Docket No. 50-346

NRC letter dated October 30, 1985 (Log 1844) requested additional information regarding main steam piping. Specifically, Question No. 5 requested:

The Toledo Edison Company
Davis-Besse Nuclear Power Station
Bechtel Job 12501
FCR NO. 85-224
MAIN STEAM SYSTEM
File: 0270, 1496
BT-15977 (A218)

DRAWING CHANGE NOTICE

PART PLAN @ EL 643'-0"

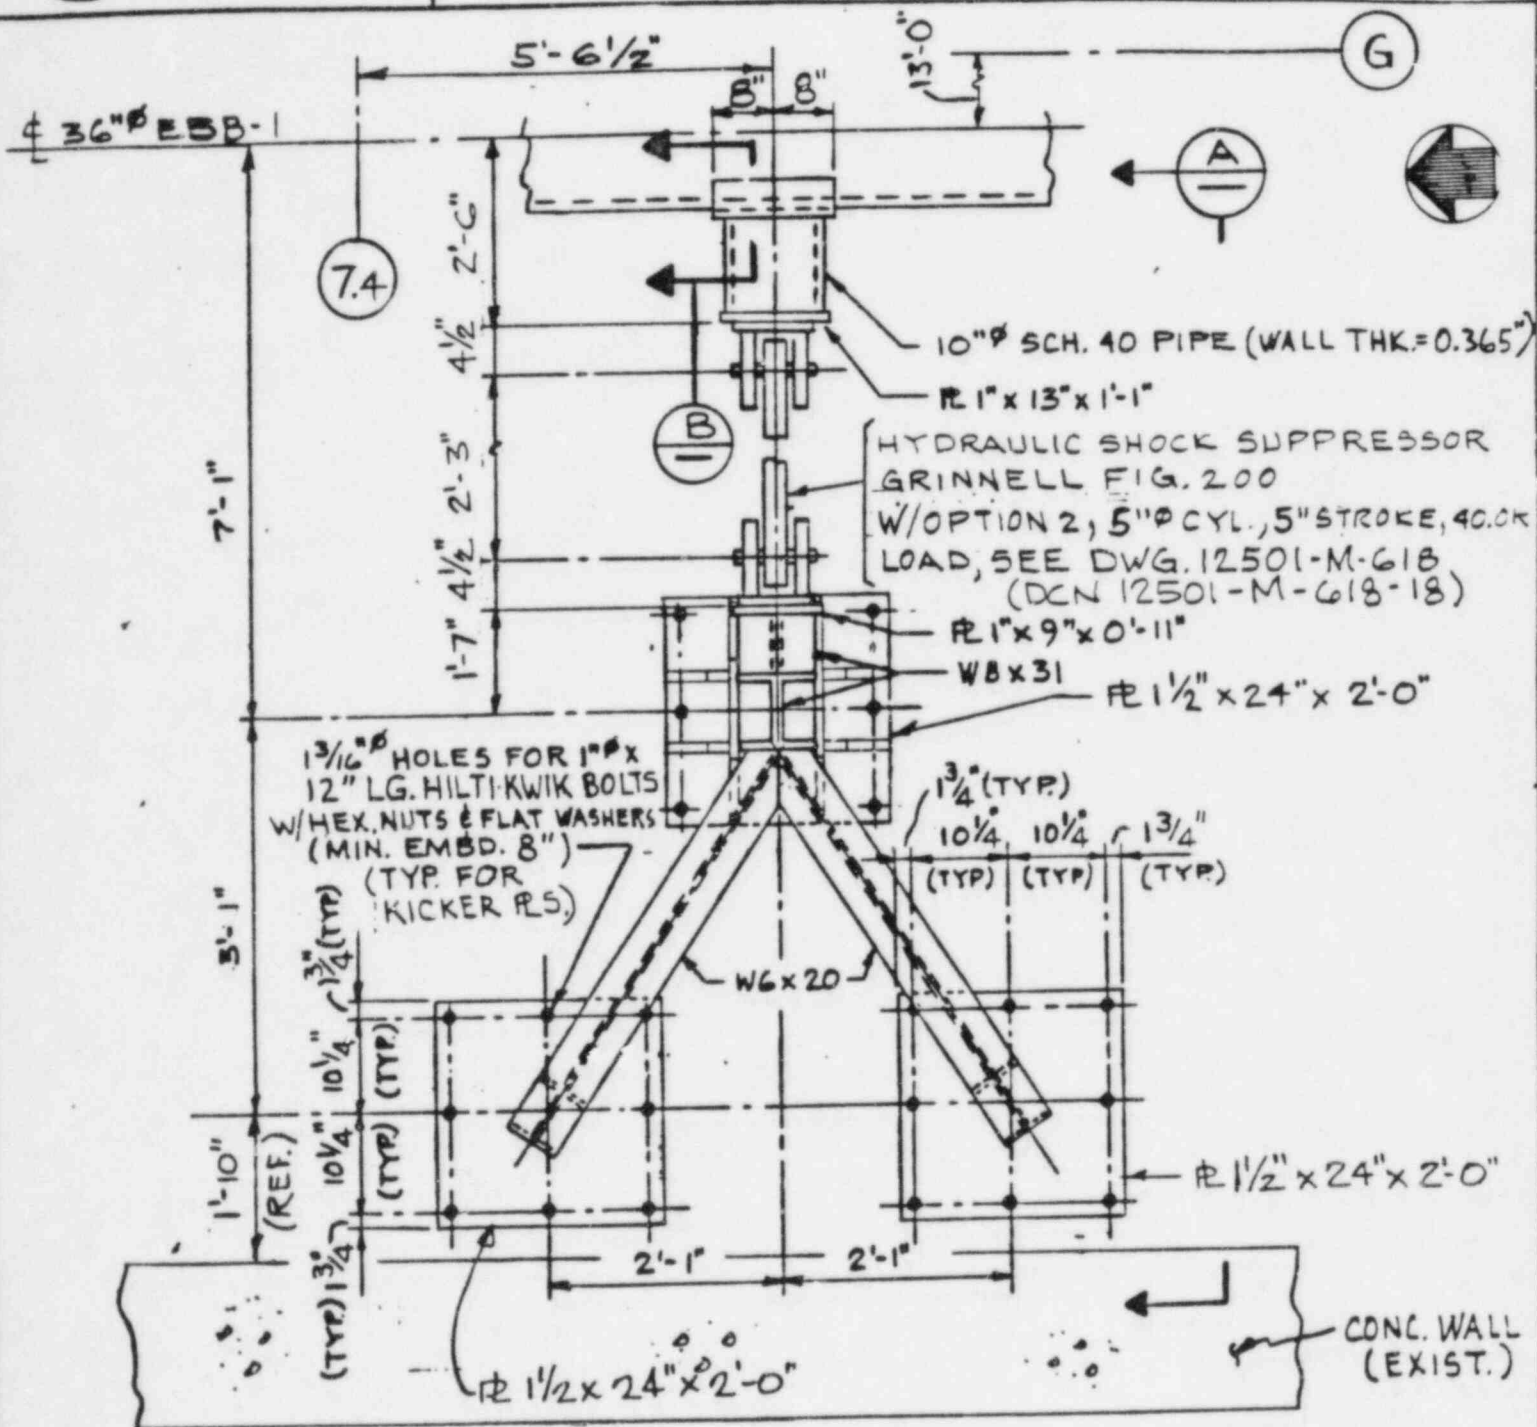
FOR PLAN VIEW SEE PAGE 2

JOB NO	DRAWING NO	REV NO
12501	12501-C-279A	1
DCN NUMBER C-279A-1		
CONTINUATION SHEET		
PAGE 3 OF 6

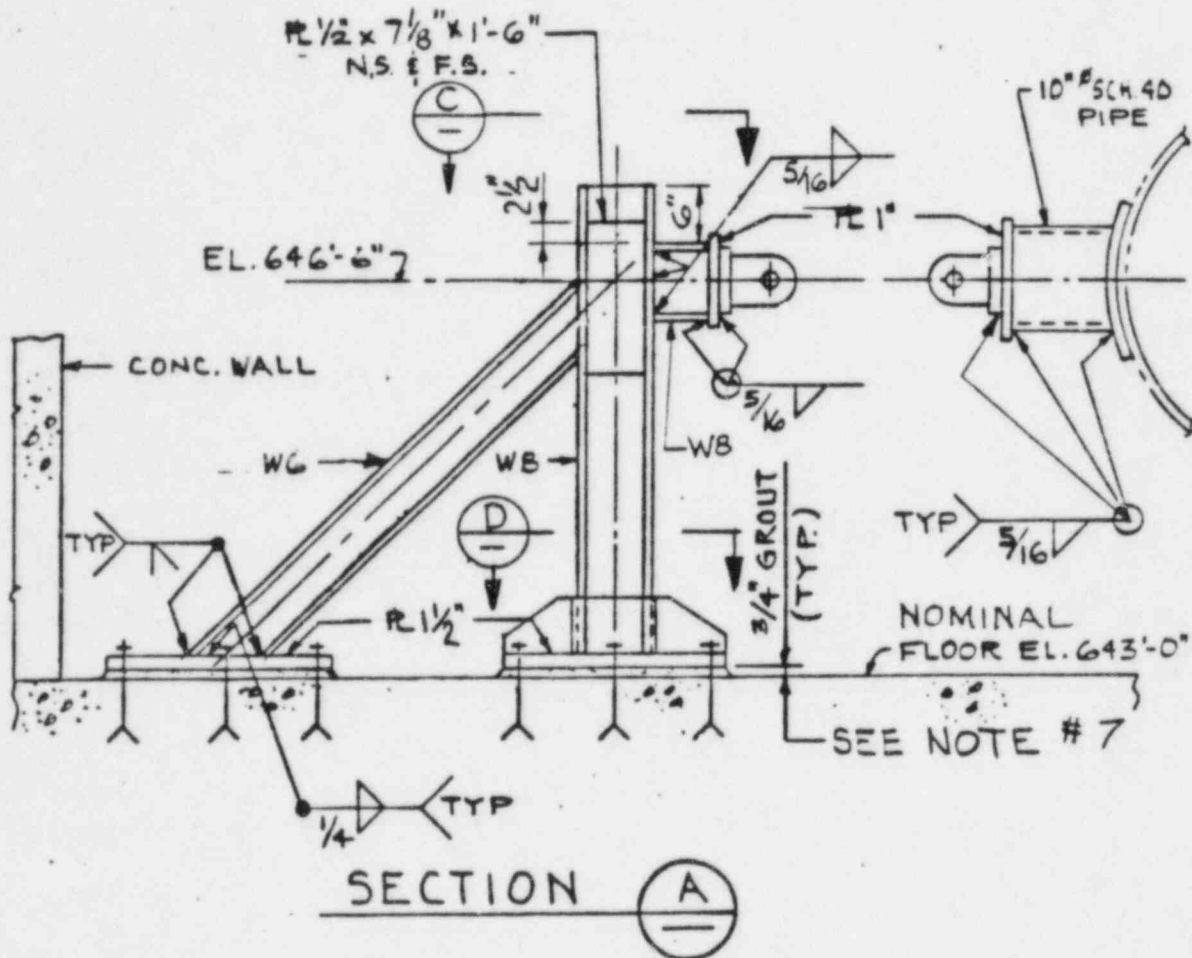
ISSUED FOR FCR 85-224

JOB NO	DRAWING NO	REV NO
12501	151M-203B	2
DCN NUMBER	PAGE	OF
151M-203B-1	1	1

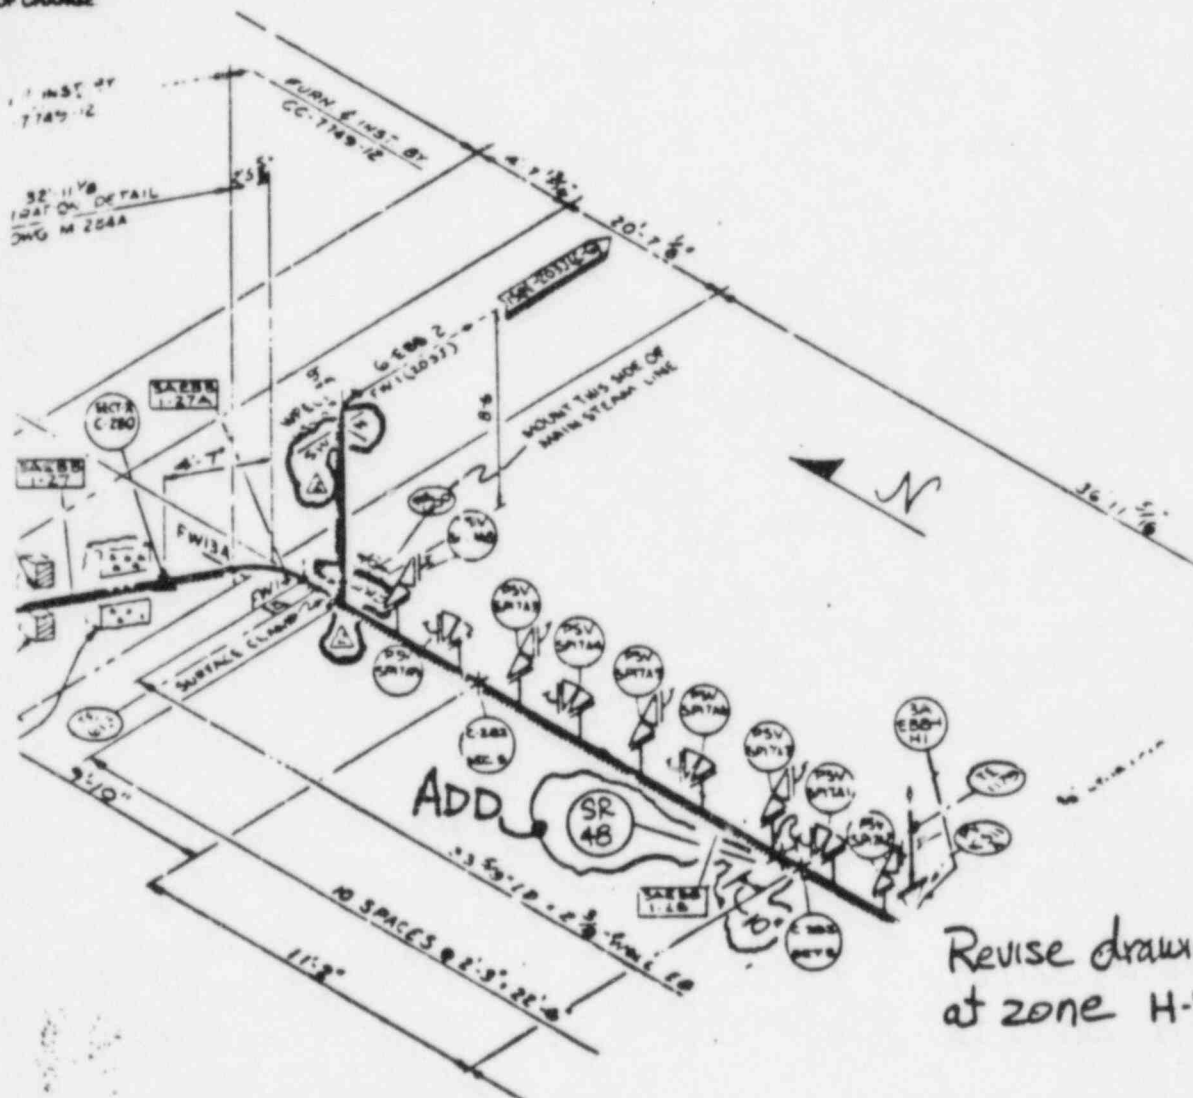
FCR 85-224

PART PLAN-MAIN STM. SYSTEM GEN. 1-2

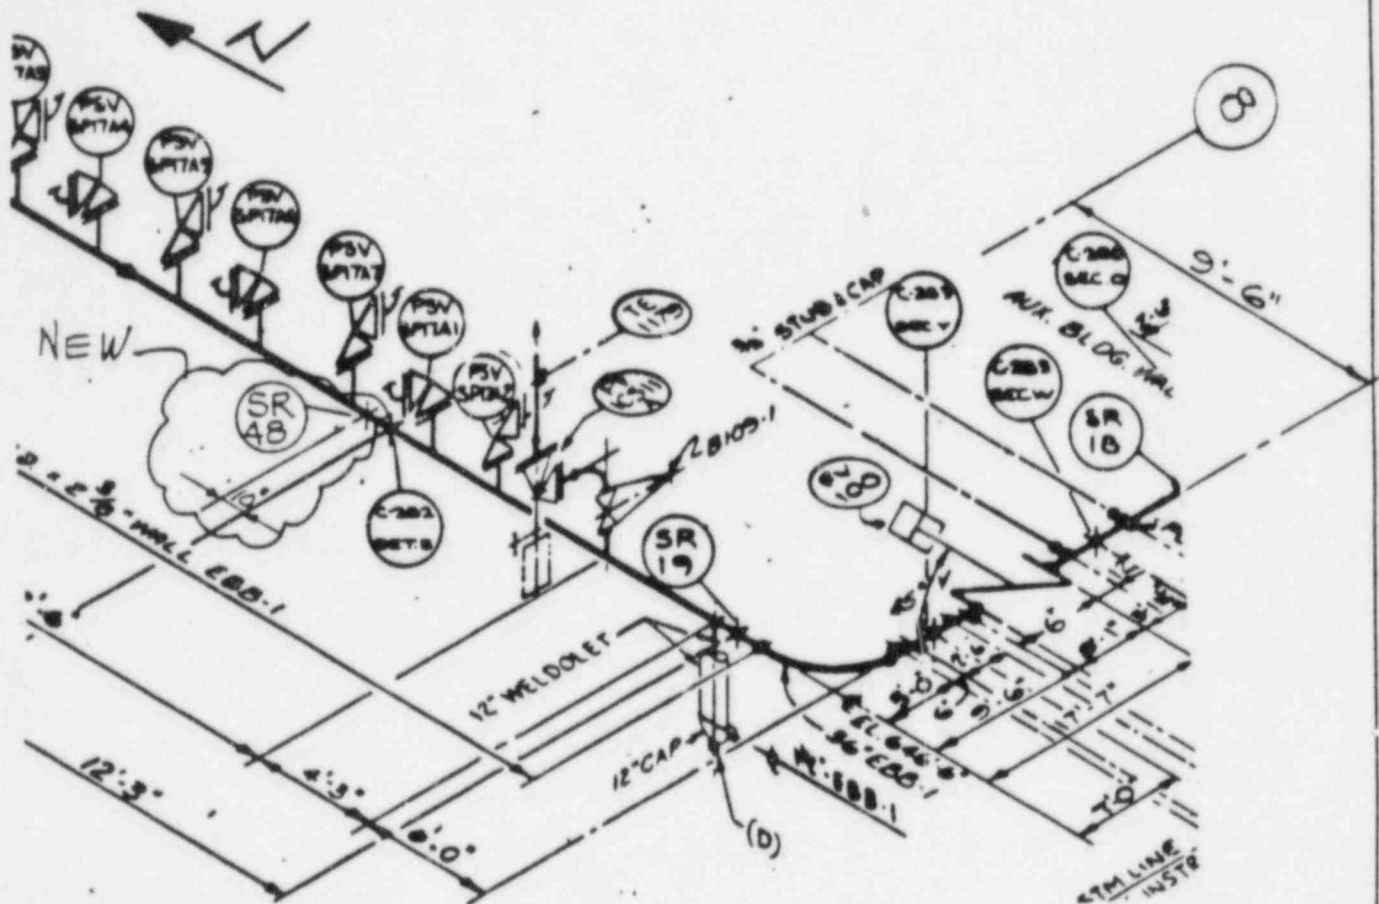
ISSUED FOR FCR B5-224
